U.S. NUCLEAR REGULATORY COMMISSION
REGION V

Report No.: 50-397/90-20
Docket No.: 50-397
License No.: NPF-21
Licensee: Washington Public Power Supply System (WPPSS)
P. O. Box 968
Richland, Washington 99352
Facility Name: Washington Nuclear Project No. 2 (WNP-2)
Inspection At: WNP-2 Site, Benton County, Washington 70775
Inspection Conducted: September 4 through September 13, 1990

Emergency Operating Procedures Inspection conducted September 4-13, 1990
(Report 50-397/90-20).

EXAMPLE 1

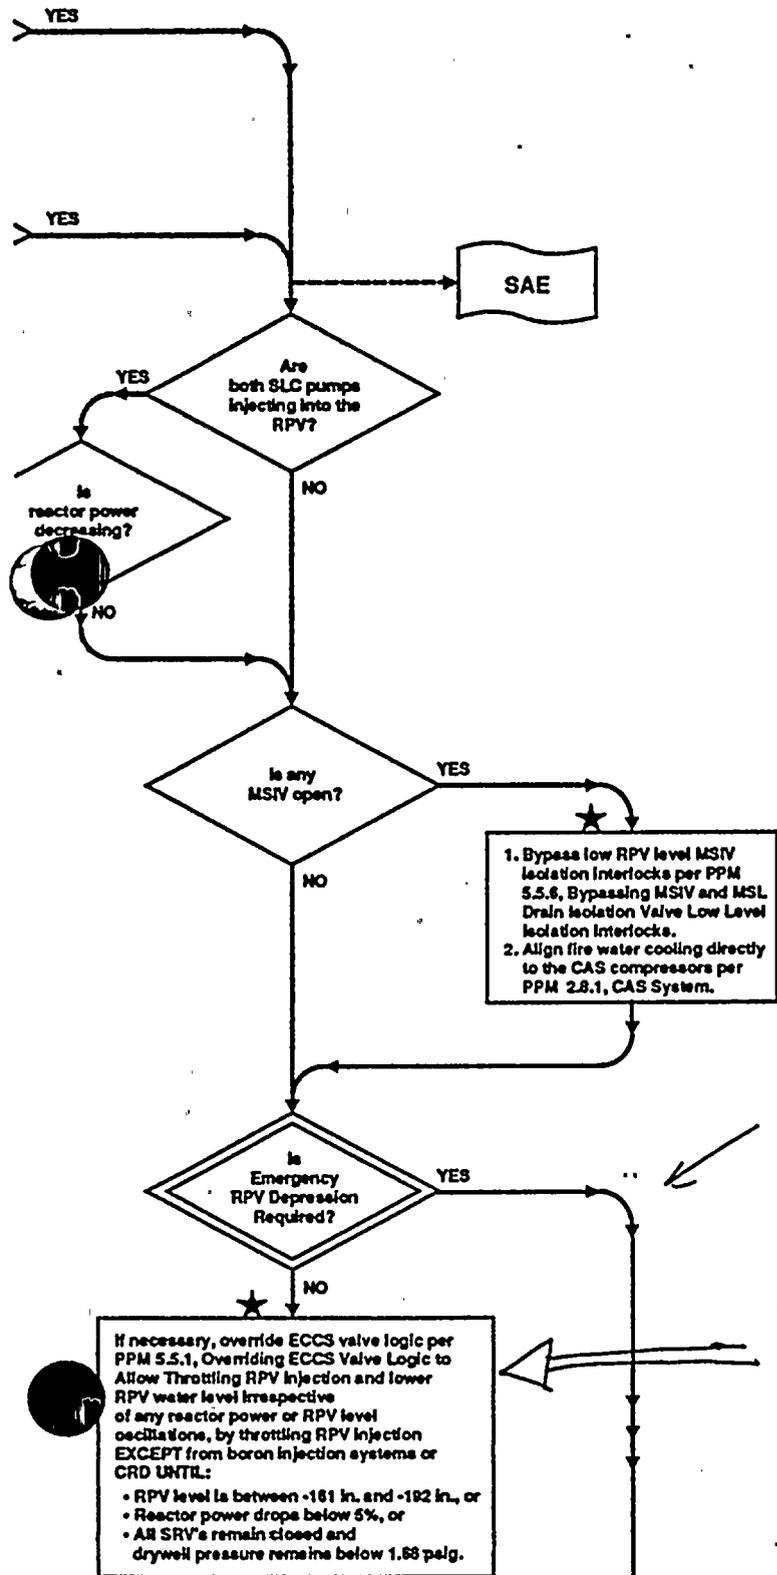
- (1) EOP 5.3.1, Secondary Containment Control, Revision 6:
See Attachment B, Example #1 for the flowchart under discussion.

The decision block that stated, "If an area temperature exceeds its maximum safe operating temperature in more than one area (Table 1)," could be misleading. Table 1 referenced by the step contains many "areas" (left to one's interpretation of, "area"). Both areas and rooms are called locations on the table. For example, the table references the RWCU Pipe Routing Area R511 and the RWCU Pump Room, and if the operator interpreted this area and room as only one area, appropriate action would not be taken. The intent of the step is to take action when any two "locations" exceed maximum safe operating temperature. Misreading the step could result in failure to depressurize the plant as required. This same style decision block appears in all three legs of this procedure. This human factor deficiency should have been identified during the EOP developmental phase.

EXAMPLE 2
(5.1.2)

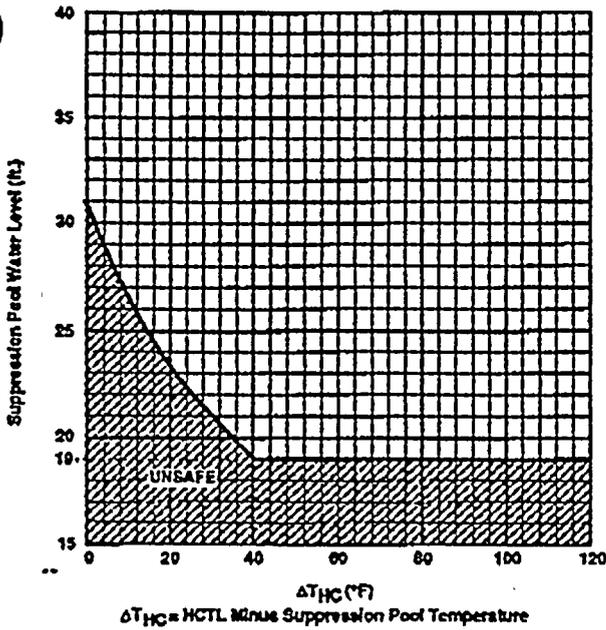
- (2) EOP 5.1.2, "Failure To Scram," Revision 6:
See Attachment B, Example #2 for the flowchart under discussion.

The procedure had a confusing step which had potential to cause errors in performing safety-significant actions. The EOP step that started with "If Necessary, Override ECCS Valve Logic per 5.5.1, . . ." was confusing to operators, because "If necessary" could be taken to apply to the entire step of lowering RPV level rather than just to the action of overriding ECCS interlocks using an ESP support procedure, as intended. The step should start with and emphasize the required action. In this case the action is obscured by the long procedure title and modifier, "If necessary." The step should be clarified. This wording is contrary to accepted human factors standards.

EOP GRAPHS, 5.0.1

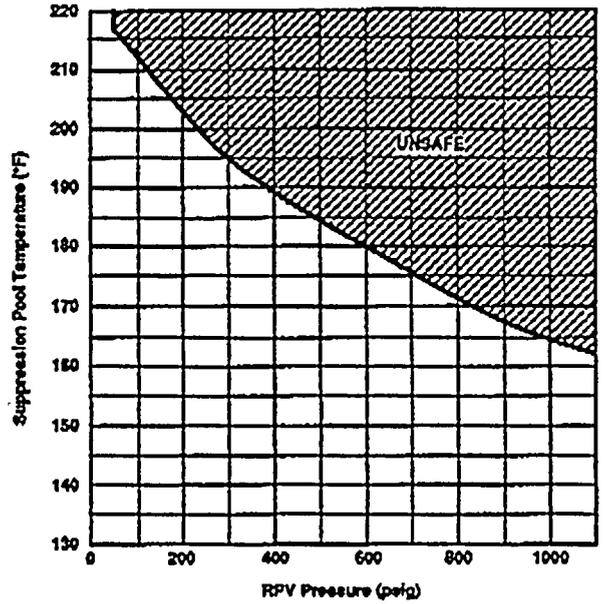
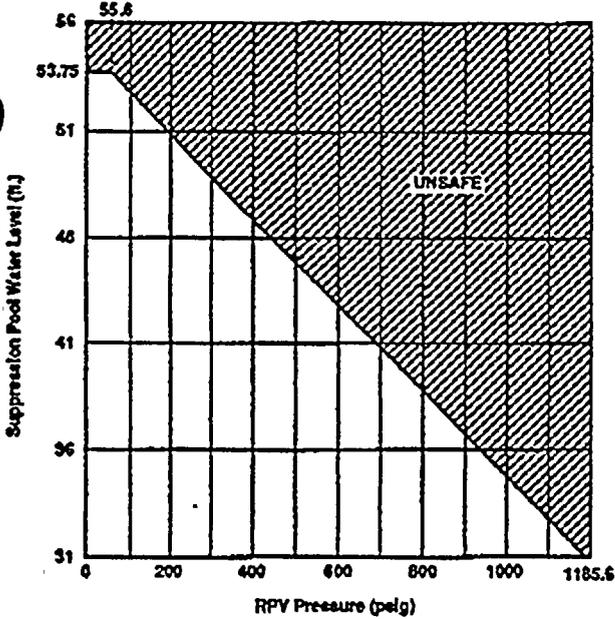
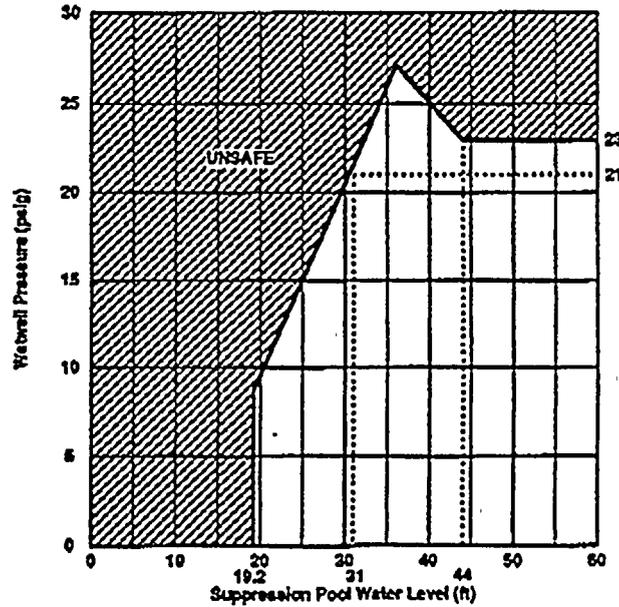
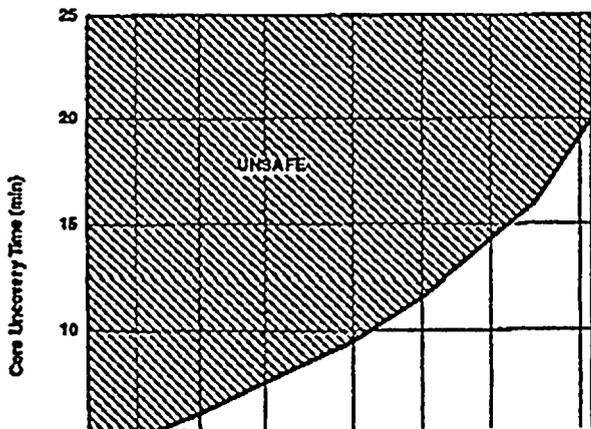
(Open) Open Item 50-397/90-20-06, Calculational Errors in EOP Graphs. EOP 5.0.1, EOP Graphs, Revision 0, Heat Capacity Temperature Limit (HCTL) and Pressure Suppression Pressure Limit (PSPL) curves did not agree with the calculations from General Electric and WNP-2 engineering, NE-02-89-20, Revision 0, and NE-02-89-27, Revision 0. The inspector found a non-conservative error in the PSPL where the EOP graph did not match the calculation. The licensee acknowledged the error and considered the event reportable. The error was subsequently reported to the NRC under 10 CFR 50.72.

Upon further review the licensee identified another error in the HCTL curve. These errors would have allowed degraded plant conditions to continue in the "unsafe regions" of these graphs. The licensee subsequently documented the errors in Problem Evaluation Report (PER) 290-698 on September 13, 1990.

(PPM 5.1.1)
EXAMPLE #4A

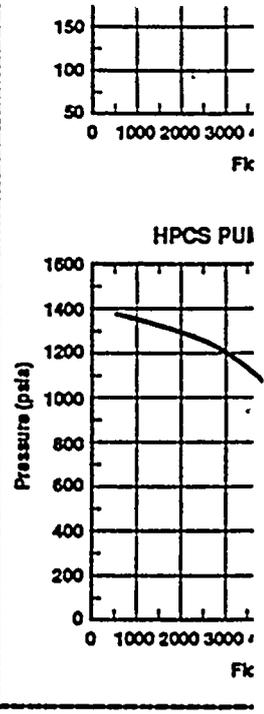
Several different types of weak decision steps were identified in the WNP2 EOPs/ESPs. Some were due to inadequacies in the writer's guide. Examples 4a and 4b, of Attachment B illustrate the following human factors concerns:

The WNP2 writer's guide allowed alternative designs for the same type of logic step. The "continuation condition step" described on page 38 was essentially the same type of step as the "hold point" described on page 39. Because the flowchart format of the EOPs used design as well as the content of a step to convey meaning, different designs suggested different meaning and therefore different types of action to operators.

The writer's guide design for "continuation condition" steps splits the condition from its contingent action. The condition was attached to the previous action symbol. This structure suggests a relationship that may not exist, it increases the length and complexity of the step, and it interferes with the link between a condition and its contingent action. The failure to use some form of emphasis to clearly identify the contingent action (such as "THEN") also reduced the link between the condition and contingent action. Two different operators experienced difficulty in using this type of structure during simulator exercises. This indicated a potential for operators errors on safety-significant actions during emergencies.

Movement within and between procedures can be disruptive and confusing, and cause unnecessary delays and errors. Therefore, when it is necessary for an operator to reference other procedures or exit one procedure and branch to another procedure, it is particularly important that the instructions be clearly and consistently structured. The WNP2 writer's guide directions on referencing and branching (pp. 13, 31-32) was unclear. Its definitions of referencing vs. branching provided no clear distinction. Examples 4a and 5, of Attachment B, illustrate these concerns.

RPV FLOODING IS REQUIRED

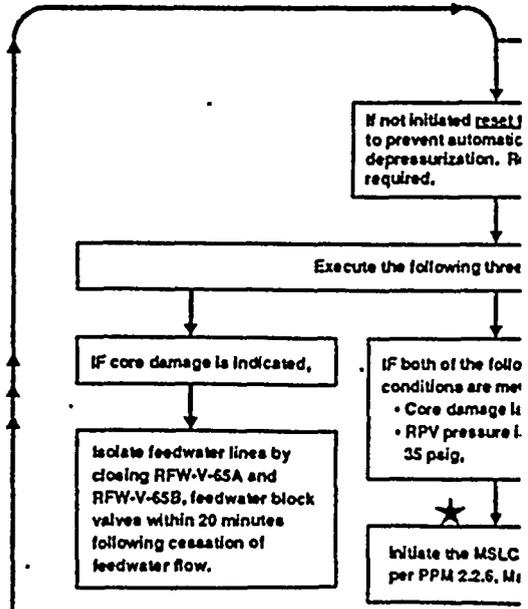
"Contingency condition callouts," such as "RPV FLOODING IS REQUIRED," are used within the flowcharts. However, these callouts are placed within an action step symbol. As a result, they appear to direct the operator to transition directly from the callout to the necessary contingency. During simulator exercises, an operator attempted to transition directly from such a symbol, which would have resulted in skipping an important decision symbol. (See Example 5, of Attachment B).

EXAMPLE 6

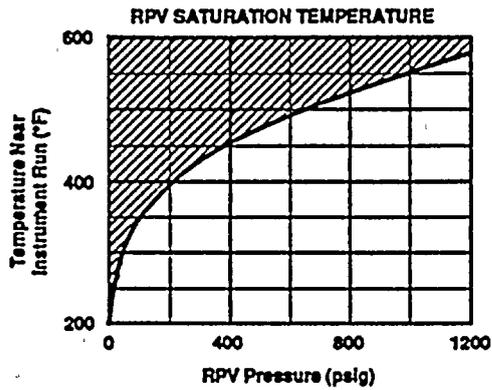
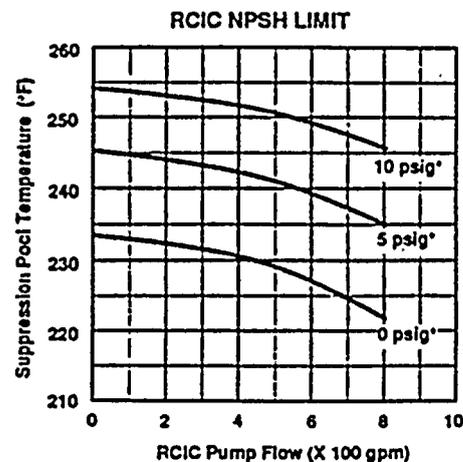
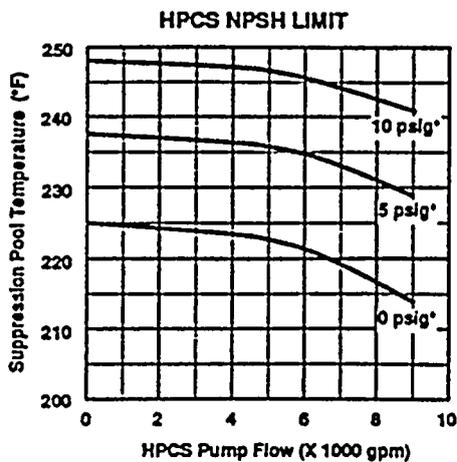
EOP Caution 1, "RPV Level Instruments," EOP 5.0.0, "EOP Cautions," Revision 1, concerned the temperature effects on instrument line runs which affect RPV level instrument accuracy. The caution required operators to know the temperature near RPV level instrument line runs in the secondary containment, to determine if fluid in the instrument lines was near the saturation temperature for the RPV pressure. If the temperatures in these areas reached or exceeded saturation conditions, RPV level indications could be erroneously high. This would mislead operators, and could lead to further degradation of the event. However, WNP-2 does not have remote or local reading temperature instruments for instrument line runs to determine these temperatures. Also, portable instruments were not pre-staged and available to compensate for the lack of installed instrumentation.

It was also noted that the licensee changed the wording of the caution from the EPG, Revision 4 guidelines. The wording was changed from keep the temperature "below the saturation temperature" to do not permit the temperature to go "above the saturation temperature." The change was non-conservative as the WNP-2 wording omits the case of temperature "equal to the saturation temperature." If the temperature near the instrument lines was equal to the saturation temperature, reliable RPV level reading could not be assured.

The caution, as it was implemented by the licensee, was non-conservative and could result in operators using unreliable RPV level instruments.

Cautions call operator attention to potential equipment damage or personnel injury. Because of the critical nature of this information, cautions should be emphasized and located where they will not be overlooked. WNP-2's EOPs place all of the EOP cautions in PPM 5.0.0, "EOP Cautions." This placement of cautions in a separate procedure makes it difficult for operators to use the information. During simulator scenarios, operators did not always read the cautions. If the information in cautions is truly critical, operators should not be required to transition to another location to read it. If the information in a caution is superfluous, it should not be contained in a caution. (See Example 6, of Attachment B).

EXAMPLE 7
5.2.1

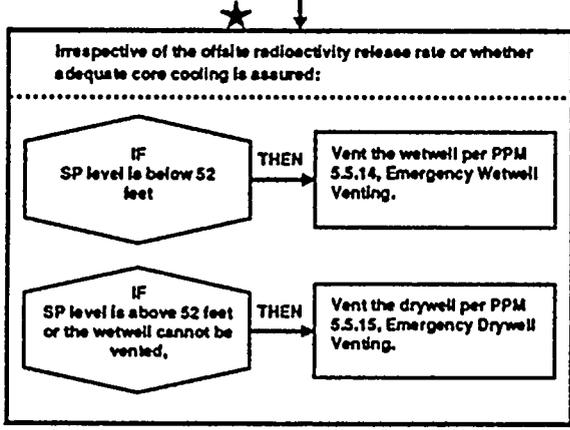
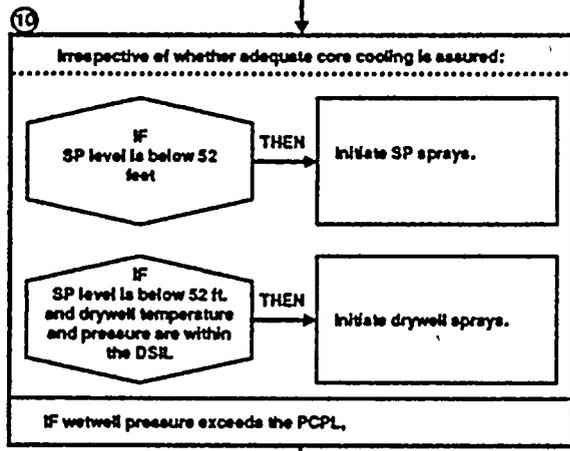
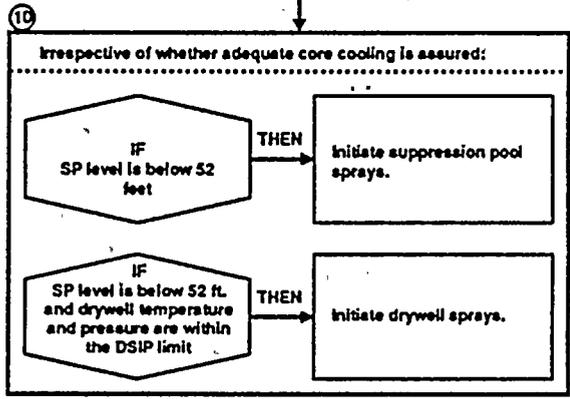
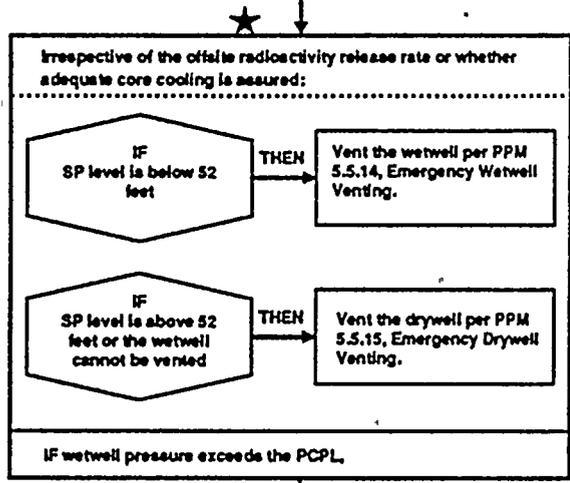
EOP 5.2.1, "Primary Containment Control," Revision 5, Primary Containment Pressure flowchart contained a significant deviation from the BWROG EPGs, Revision 4. The deviation concerns venting containment with core damage greater than 10%. The EPG criteria requires venting containment to the environment if containment pressure cannot be maintained below the Primary Containment Pressure Limit (PCPL). If primary containment pressure cannot be reduced, the EPG directs spraying the drywell (at the expense of core cooling, if necessary, since water would be redirected to containment spray, from direct Reactor Pressure Vessel (RPV) injection) to reduce primary containment pressure. If core damage is less than 10%, WNP-2 uses the same guidance as the BWROG EPGs, which is to vent first (regardless of core damage).

However, if core damage is greater than 10%, the WNP-2 criteria is to spray the drywell first. If the drywell cannot be sprayed, the WNP-2 guidance is to then vent the primary containment to the environment. The licensee justification for the deviation is documented in the WNP-2 EPG Deviation Document, Primary Containment Control, pages 19 - 22. The licensee justification emphasizes that because the containment is not expected to "actually yield" until pressure is well above the PCPL, the potential off-site dose is not warranted. WNP-2 states that the criteria to vent "before" the PCPL is reached is inappropriate. However, the WNP-2 justification does not provide engineering calculations or documentation to support this conclusion.

The trade-off between venting containment, at risk to the general population, and the potential to exceed the PCPL due to a delay in venting should be based on well justified and documented calculations. The team concluded this issue was significant, and that the philosophical and technical issues still need to be resolved.
